SECTION 00 91 15

ADDENDUM NUMBER 6

- 1.01 DATE: JANUARY 22, 2021**
- 1.02 PROJECT: ELMORE SPORTS MEDICINE RENOVATIONS**
- 1.03 PROJECT NUMBER: DCM NO. 2020452; PSCA NO. 2018**
- 1.04 OWNER: ALABAMA A&M UNIVERSITY**
- 1.05 ARCHITECT: NOLA | VAN PEURSEM ARCHITECTS, PC**

AD6-A1.1-01

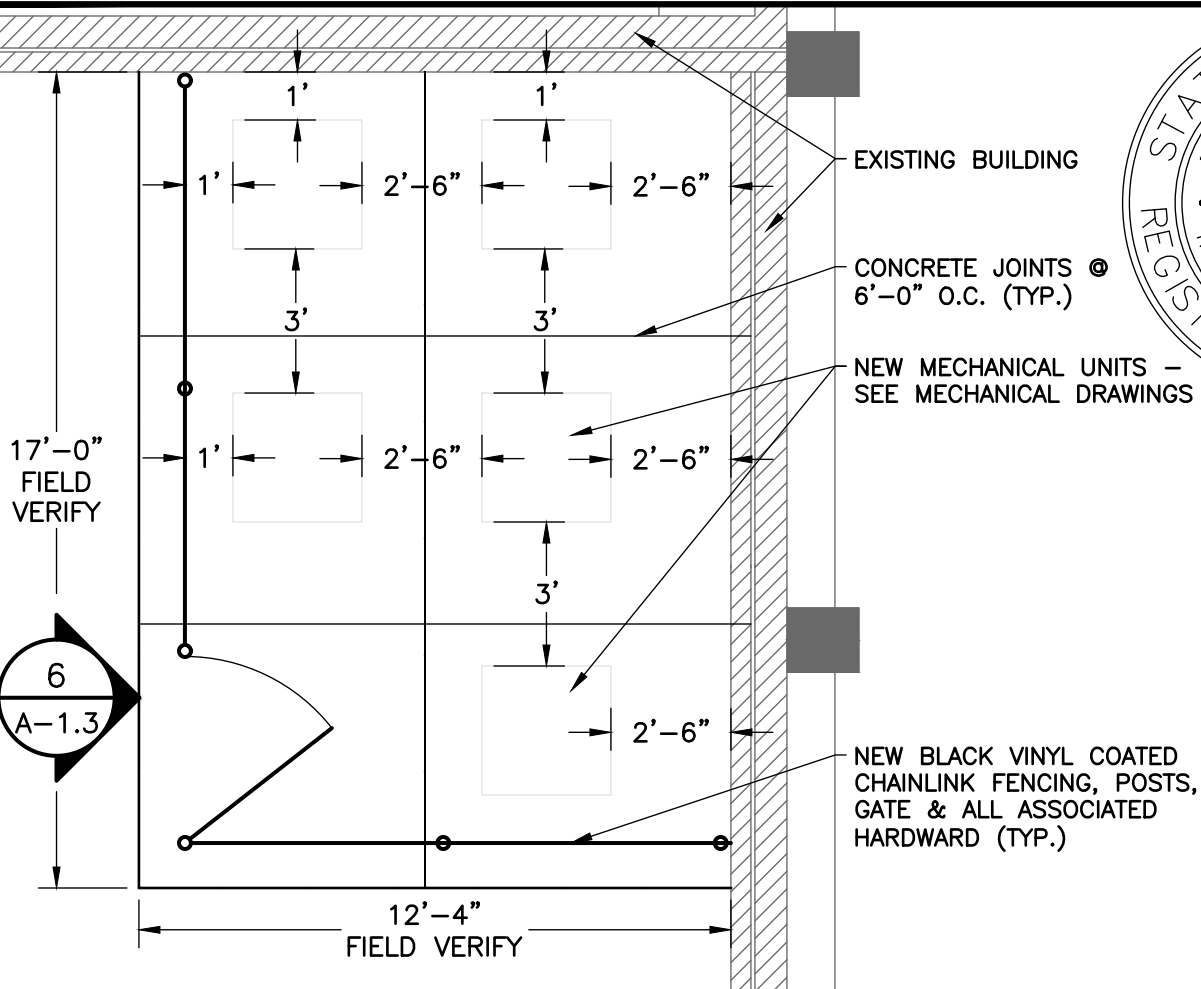
- A. See attachment AD-A1.1-01 for additional notes regarding demo work to be done below mezzanine level floor repair.
- B. Detail 2/A-1.1: Clarification: Extent of Terrazzo floor requiring floor demolition and replacement is 450 sq. ft. +/-.

AD6-A1.2-01

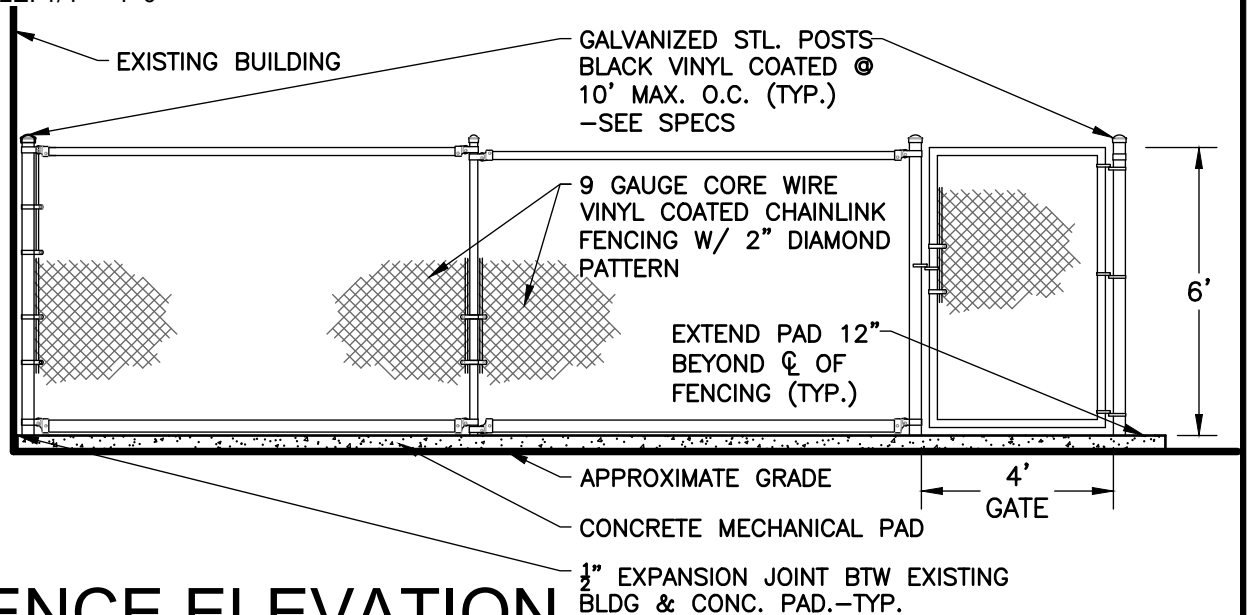
- A. Add Details 5/A-1.3 Mechanical Pad Plan and 6/A-1.2 Fence Elevation per attachment AD6-A1.2-01.
- B. See attachment AD6-A1.2-02 for revisions to 4/A-1.2 Mechanical Platform and 1/A-1.2 Partial Mezzanine Plan at Elevator. Revisions include the following:
 - 1. Added new cased opening at Mechanical Platform (see next line item regarding Door Schedule).
 - 2. Revisions to the partial mezzanine plan around the new elevator.
- C. See attachment AD-A1.2-03 for additional notes regarding construction work to be done below mezzanine level floor repair.

SHEET NUMBER
A-3.2
OF

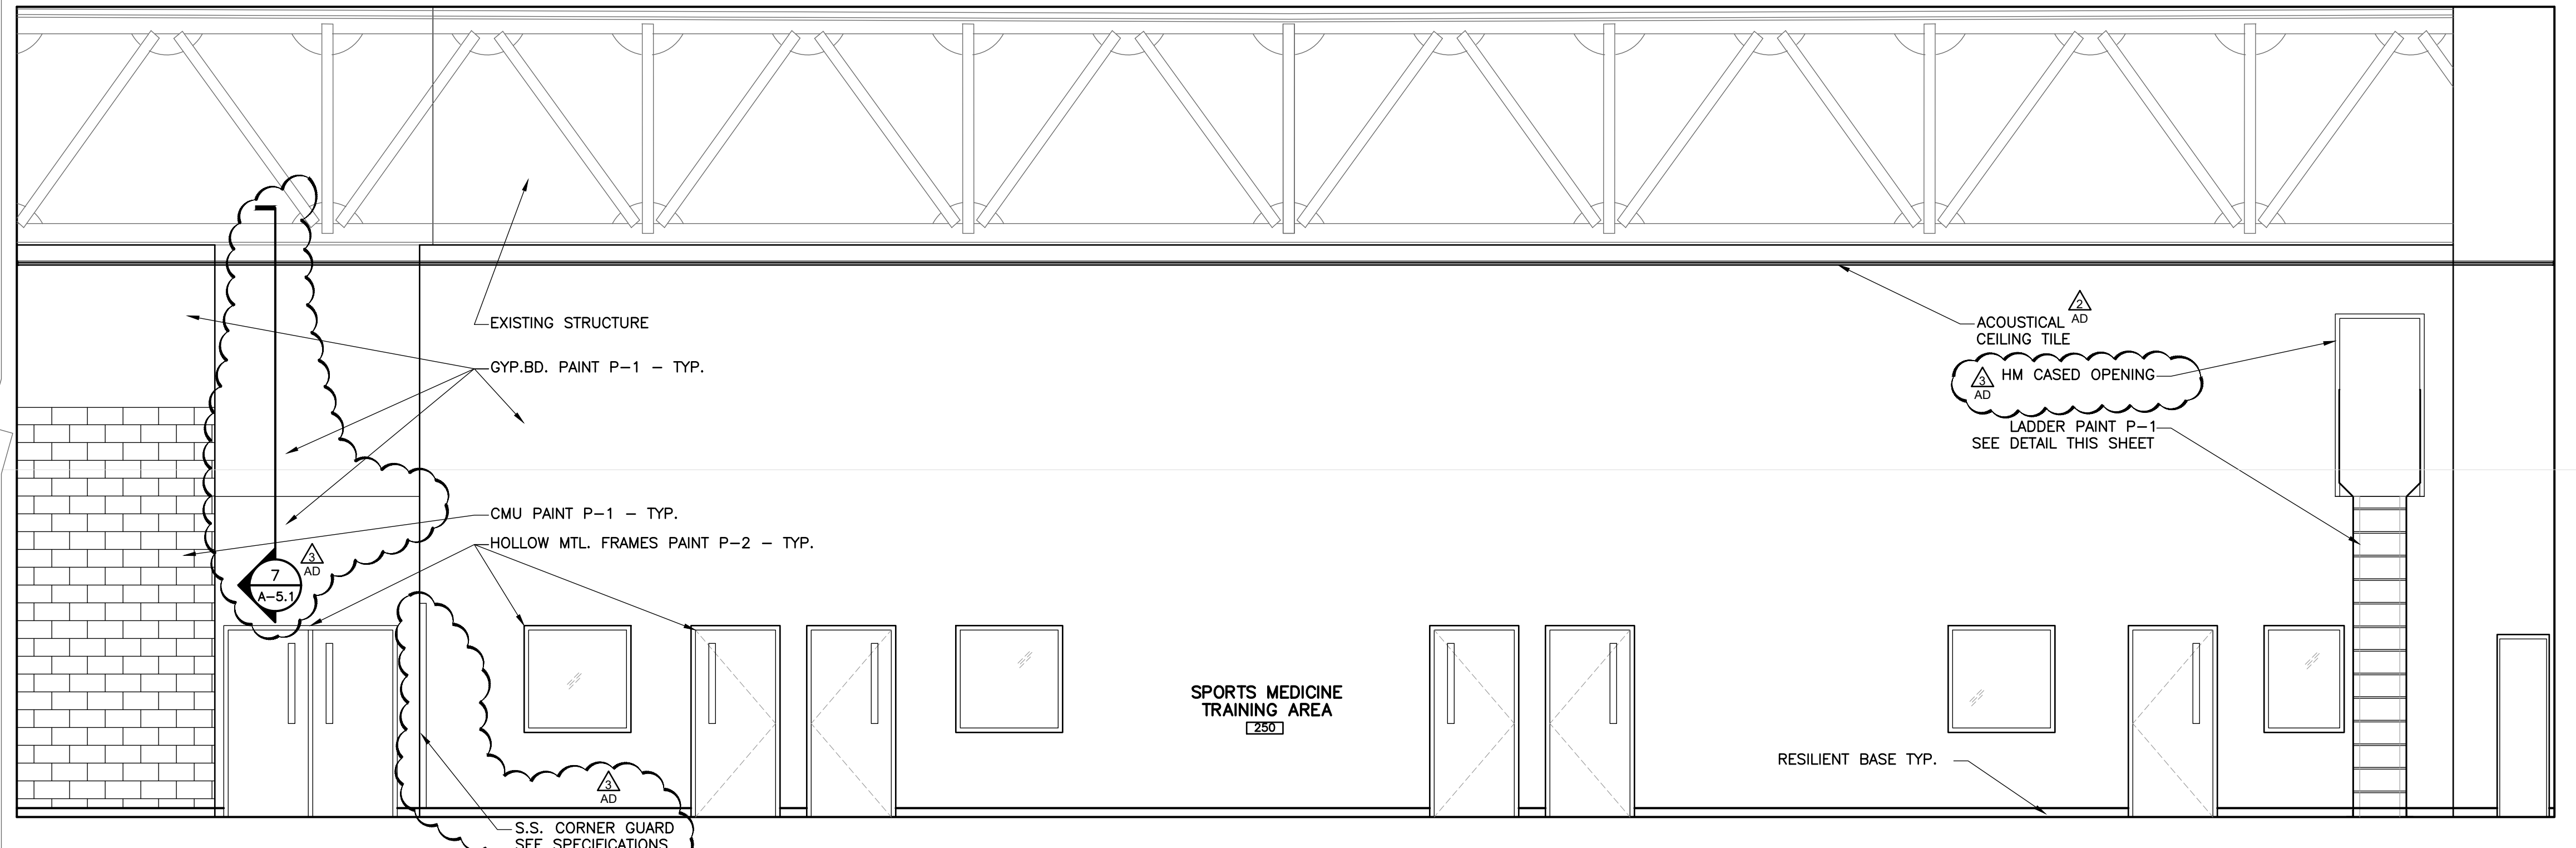
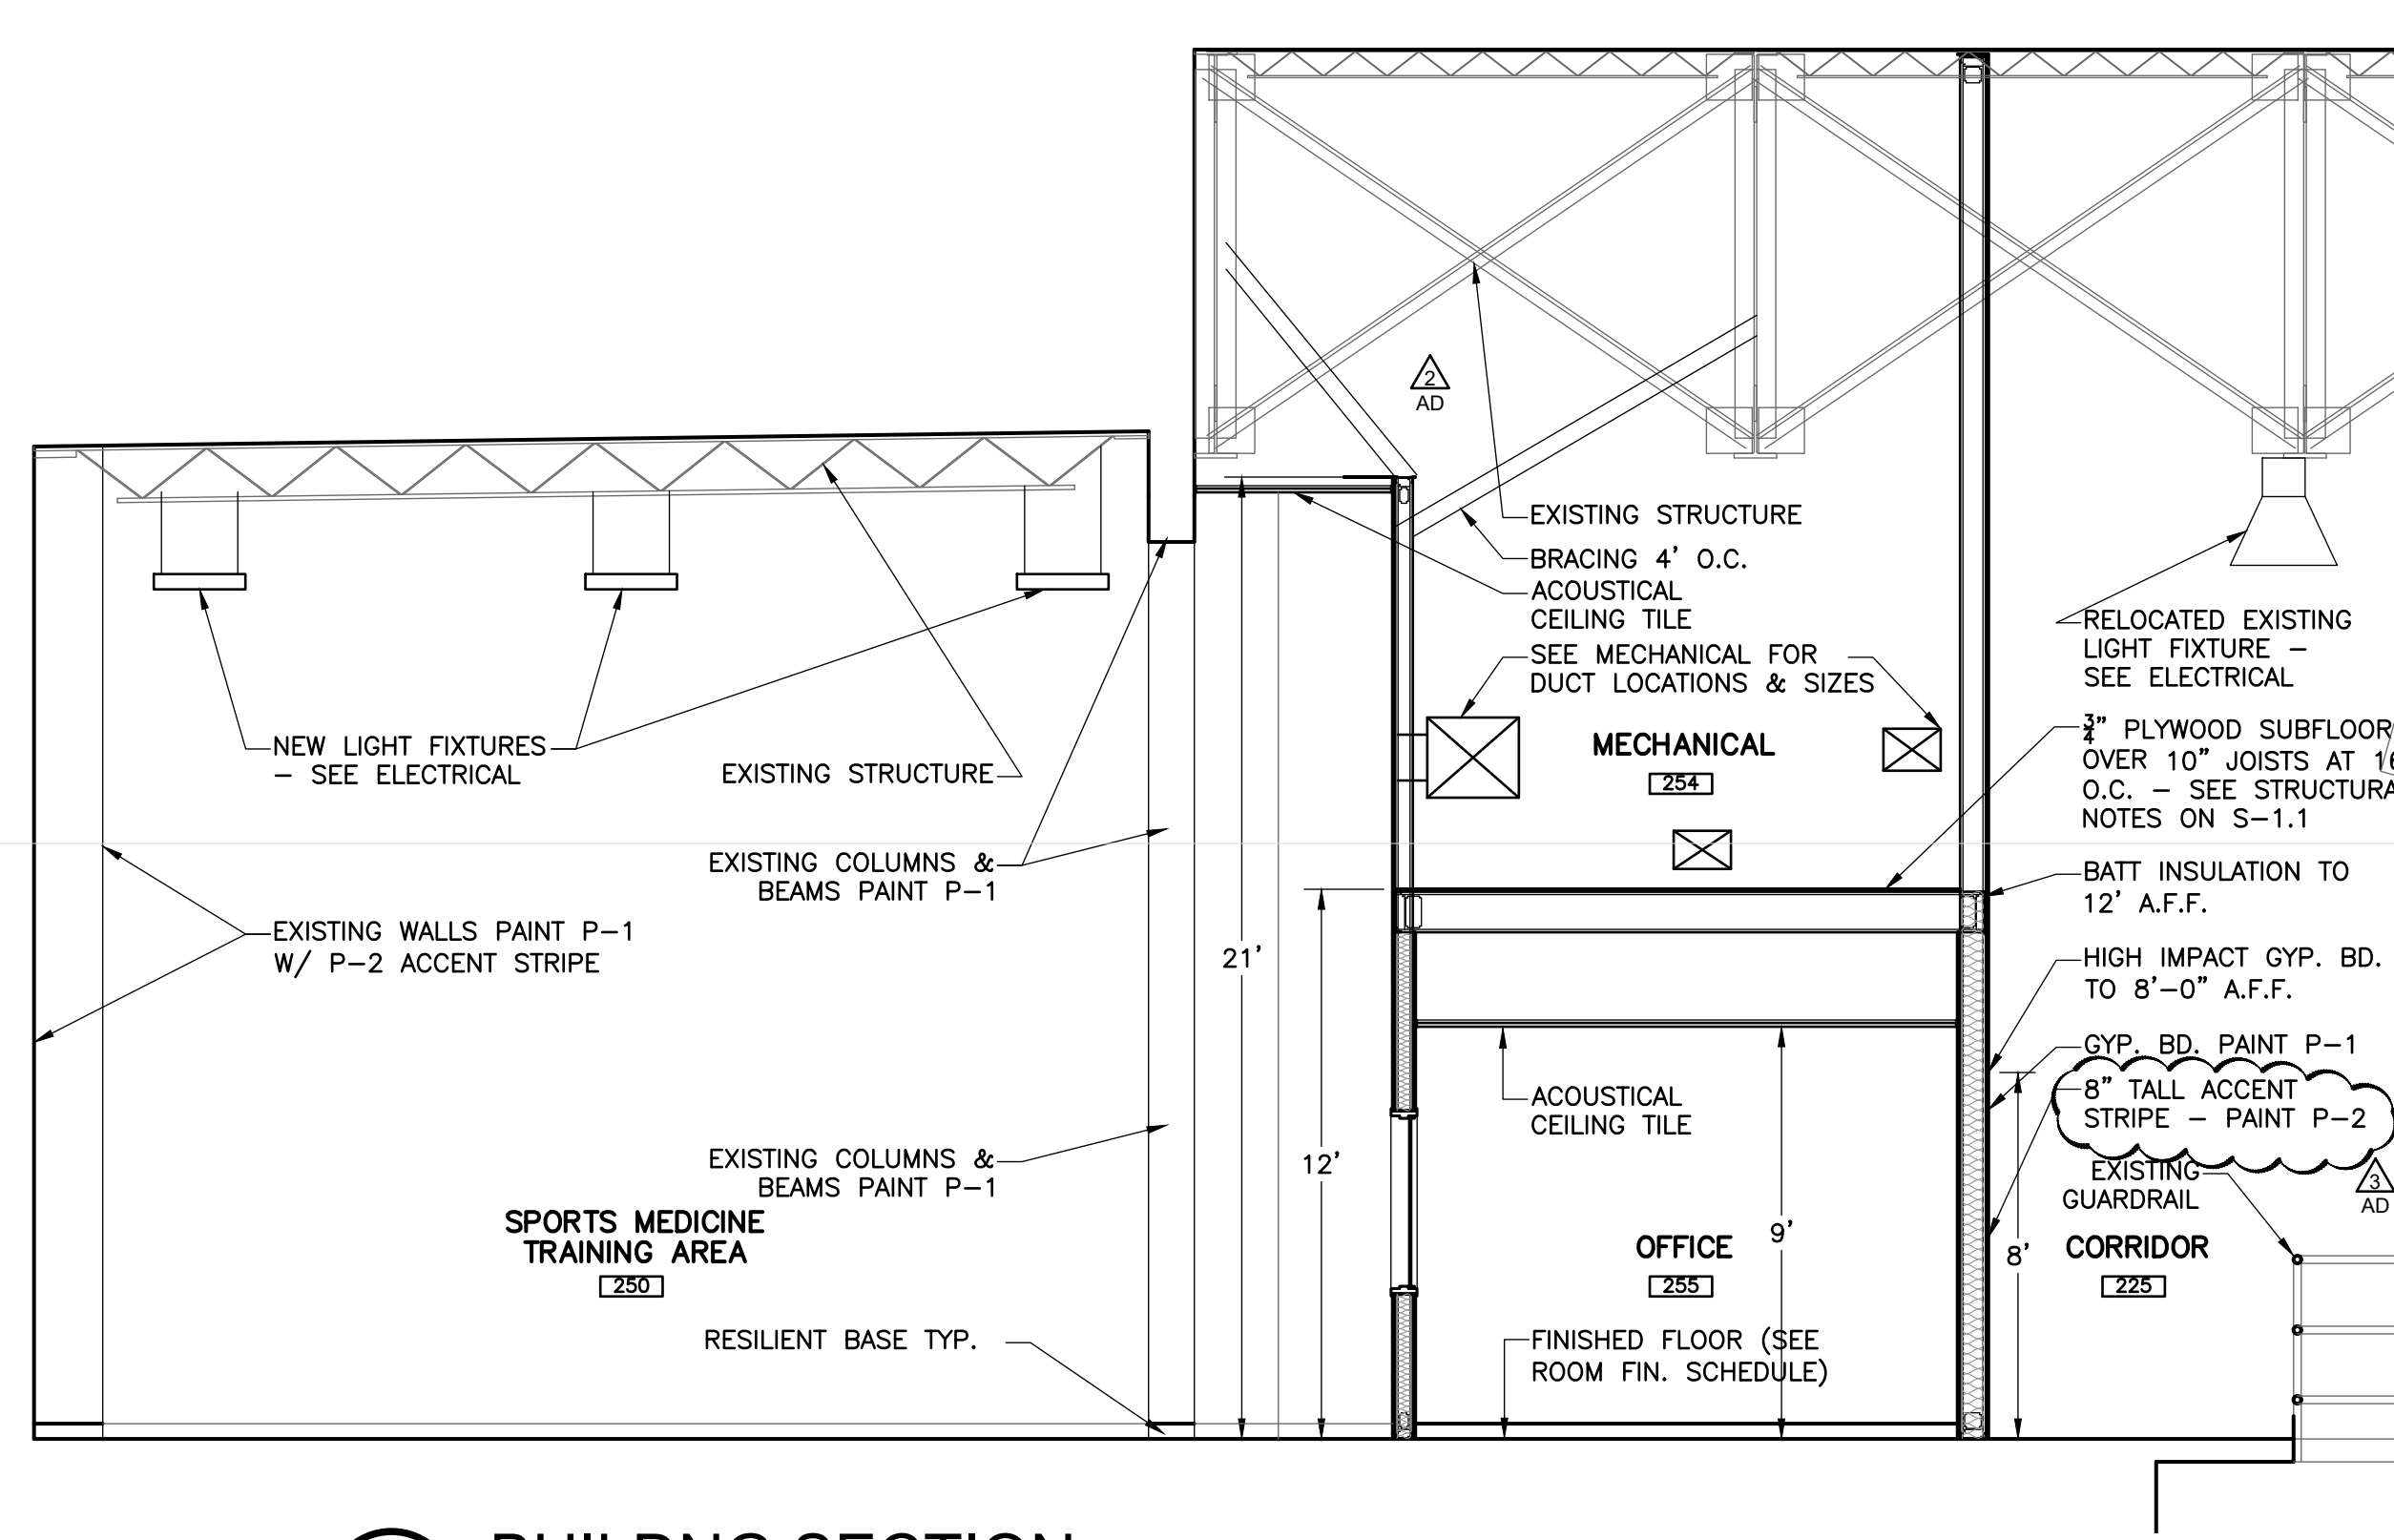
- A. Replace this sheet in its entirety. Revisions include the following:

1. Added painted accent stripe and large painted text.
2. Clarification of Mechanical grille location.
3. Revisions to elevator shaft wall finishes.
4. New soffit and lowered ceiling near elevator shaft.
5. Clarification of some corner guard locations.
